**RE: Certificate of Compliance No. 9258 for the Model No. F-294  
Request for Additional Information**

Further to our telephone conversation of May 14 and 17, 2004, please find attached the revised chapter 7 of MDS Nordion report number IN/TR 9301 F294 (4c), "Safety Analysis Report for the F-294 Transport Package," which addresses your concerns with respect to the loading of the F-457 carrier. The revision is found on page 7.3.

## Safety Analysis Report for F-294 Transport Package

2001 Jan	3c	DCN: A1232-D-12A - Ch. 1 App. 1.4.1 pp. 9, 11, 16 - Ch. 2 Table 2.3-T1 pp. 22 - Ch. 2 pp. 11-12 - Ch. 2 pp. 2.21 & 2.23 - Ch. 2 App. 2.10.6 pp. 44, 47, 50, 53, 57, 64, 65 - Ch. 2 App. 2.10.1 pp. 3 - Ch. 8 App. 8.3.2 pp. 2	F. Taylor	M.A. Charette	M. Krzaniak
2003 July	4	DCN: A1699-D-10A - Add F-457 Source Cage Data & Analysis - Update format to remove blank pgs & shorten doc - Incorporate all photos/fig's electronically - Additional changes to reflect '96 regulations	K. Desbiens	M.A. Charette	M. Krzaniak
2004 Mar	4a	DCN: A1699-D-15A - Update TOC - Ch. 1 pp. 1.12 - 1.15, App. 1.4.2 - Ch. 2 pp. 2.1 - Ch. 3 pp. 3.1 - 3.3, App. 3.6.5, Added App. 3.6.8	M. Krzaniak	M.A. Charette	M. Krzaniak
2004

**Figure 7.1-F1b**  
**Loading Diagram for the F-457 Source Carrier**

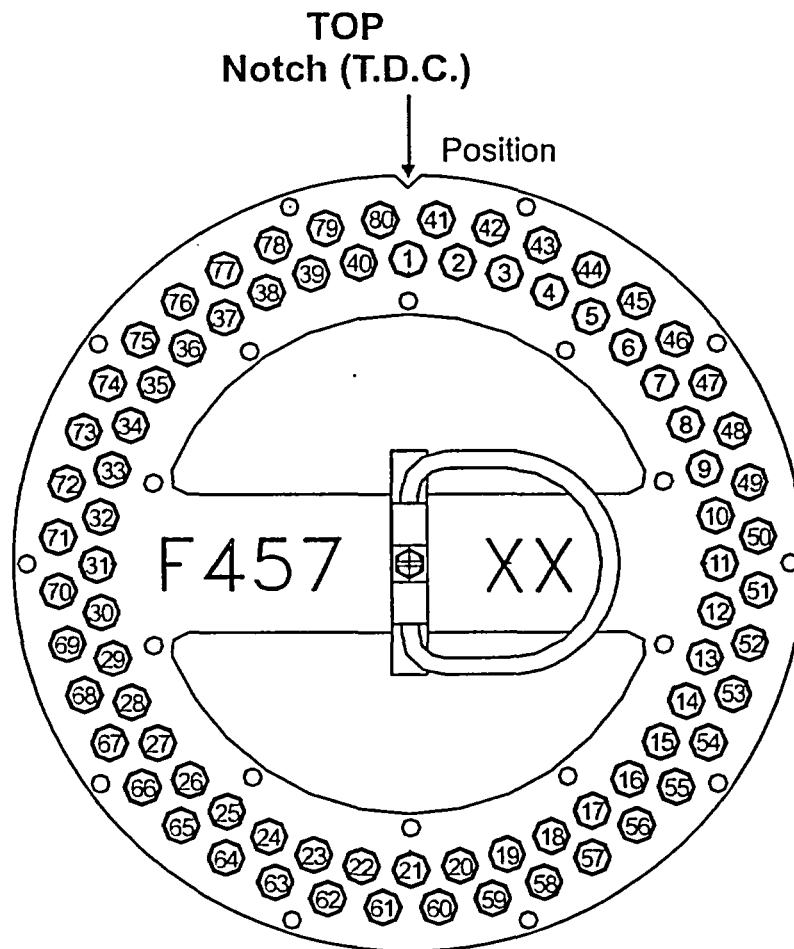
1. Load C-188s into the source carrier as per loading diagram, see Figure 7.1- F1 a, for the F-313 source carrier or 7.1-F1b for the F-457 source carrier. Do not exceed 360 kCi of Cobalt-60, the licensed limit of the F-294 transport package. Retain all wipes for the possibility of further testing. The activity should be distributed evenly around the carrier.

When using the F-457 source cage, the outer ring is filled first. For most configurations, the maximum allowable pencil activity on the inside ring can be calculated from the following formula.

$$\text{Maximum Allowable Pencil Activity on Inner Ring} = \frac{(360 - \text{Outer Ring Total Activity in kCi})}{40.0}$$

Deviations from this guideline are acceptable provided that the maximum source temperature does not exceed 482°C.
